Comments on the Informal document GRSP-69-26

The Industry has checked carefully the working document ECE/TRANS/WP.29/GRSP/2021/15 to improve it and point out some open points that have been found and need to be discussed.

Proposal of Supplement 2 to the 06 series of amendments to UN Regulation No. 22 (Protective helmets)

Annex 8 - New figure 1d, amend to read:

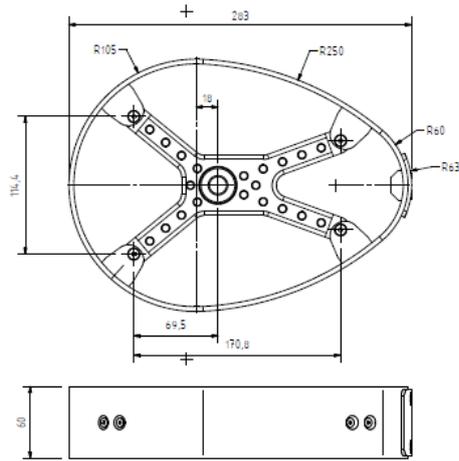
Comment: This simulator does not reproduce the actual behaviour that the accessory would have if fitted to a helmet. The helmet can rotate around the headform during the test. This simulator only gives one degree of freedom: rotation through the fixation axe

Test has been designed to be in line with the actual procedures used in the Regulation 22: the test apparatus used to assess the helmet do not foresee any simulation for the neck (such as a similar ball joints). This decision rely historically in the need to have a conservative, repeatable and cost effective test.

The helmet simulator is conservative respect the actual behavior: in the market there are helmet with close fit which has very limited movement as well as other kind where movement around the head may be more. Helmet simulator stays representative of the worst case scenario. The test campaign has demonstrated a direct correlation between pass performance between the test of the accessory when fitted on the helmet and when on the proposed simulator.

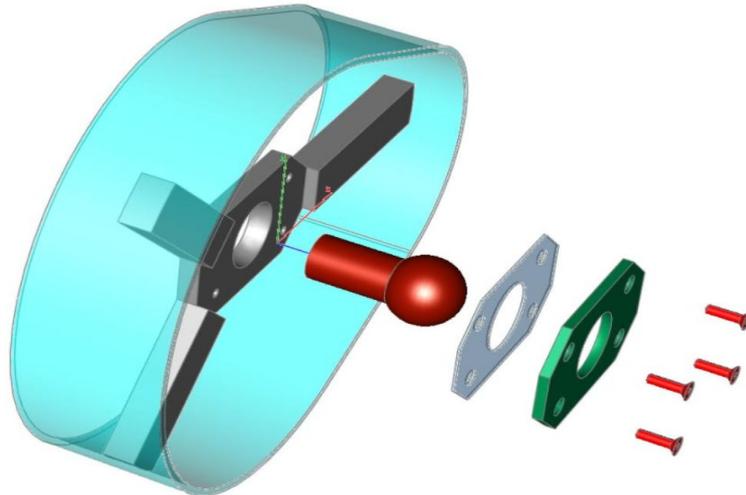
New simulator proposal with three degrees of freedom could better represent what could happen in a real test.

The new proposed system could be calibrated as it is the Hybrid III femur-hip joint.

Figure 1

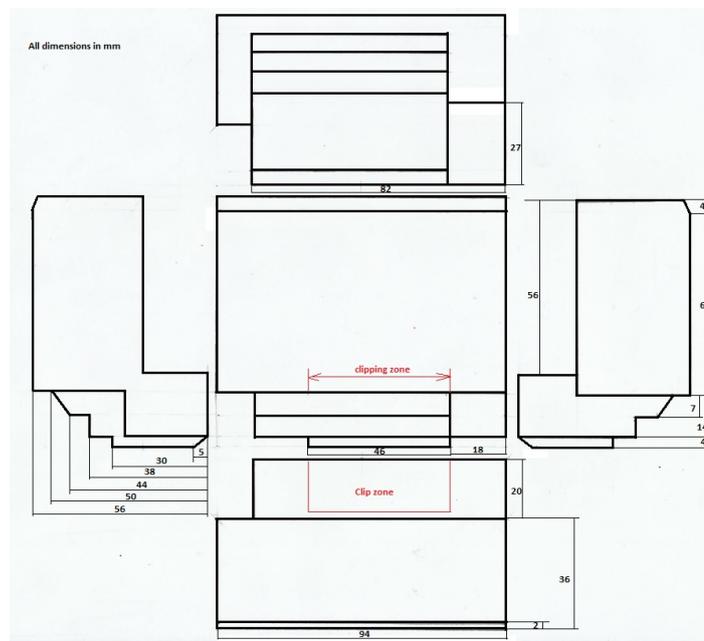
Comment: [Volume was only indicated in the document as a reference for defining the building possibilities, no need to introduce it in the text]

Figure 2

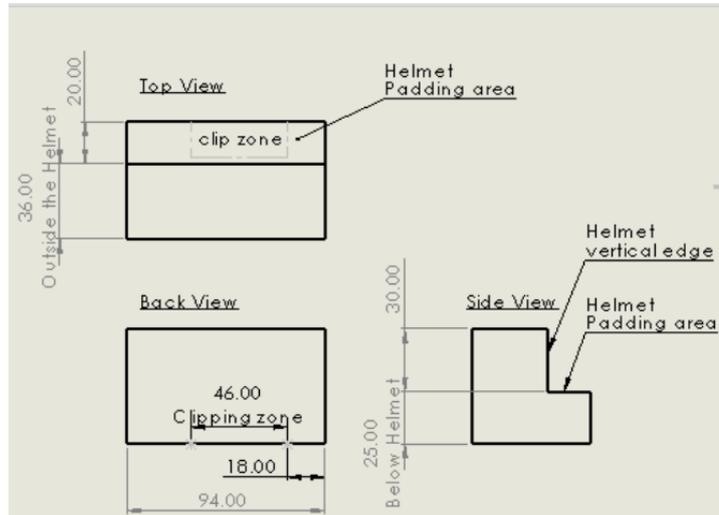
Comment: [Volume was only indicated in the document as a reference for defining the building possibilities, no need to introduce it in the text]

Figure 3

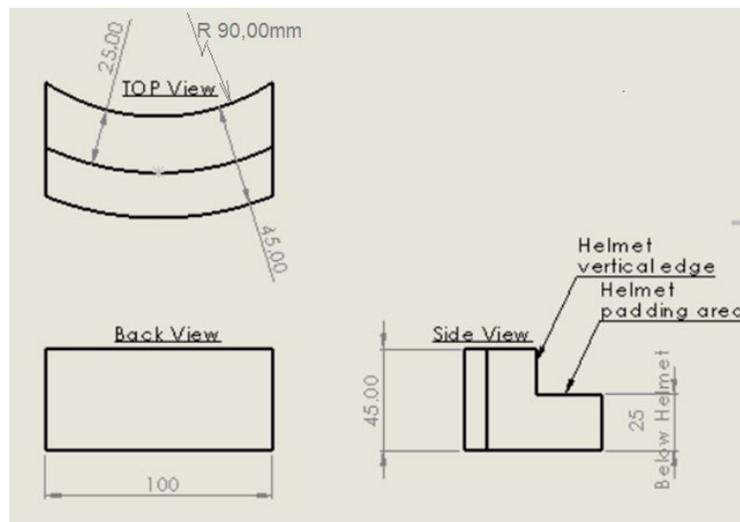
Comment: [Volume was only indicated in the document as a reference for defining the building possibilities, no need to introduce it in the text]

Example of curve

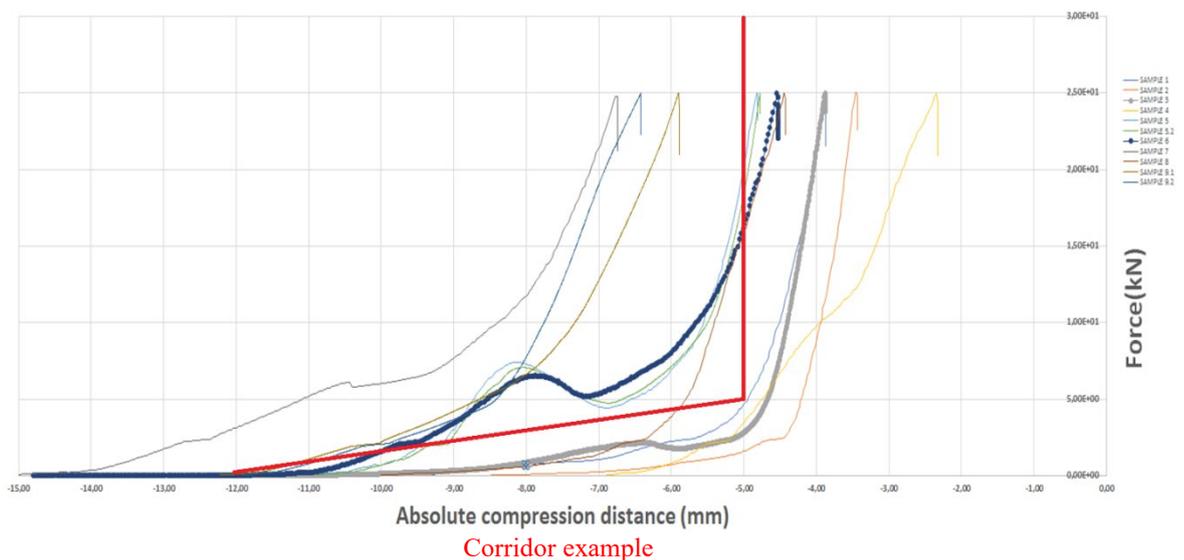
Comment: More tests are necessary. Industry does not have any clear input on the impact this might have on the helmet results. Only one or two helmets reported to be tested and no data from the conditions or geometry of the pockets or EPS or shell or even size tested.

1- There is no explanation or clear rationale to the stated need of 25kN (2500 kgf) to compress the speaker case as for most part of the speaker lower loads are enough to compress the speaker case to 8 mm, which is the height at which the liner of the helmet would start to work. This exact situation is simulated with the proposed speaker simulator 8 mm height.

Apparently, in absence of errors/misunderstandings, from the examination of the graph most of the speaker sold in the market would not satisfy this requirement.

2- BUT PLEASE NOTE: these data appears not in line with the usual experience of any user and with the data obtained by other laboratory. The user typically experience a displacement of the case of 3/4 mm simply by pressing by hands. The graph states that most of the case of the speaker will need almost 5000N to go to 8mm: it would be helpful to know which are these samples
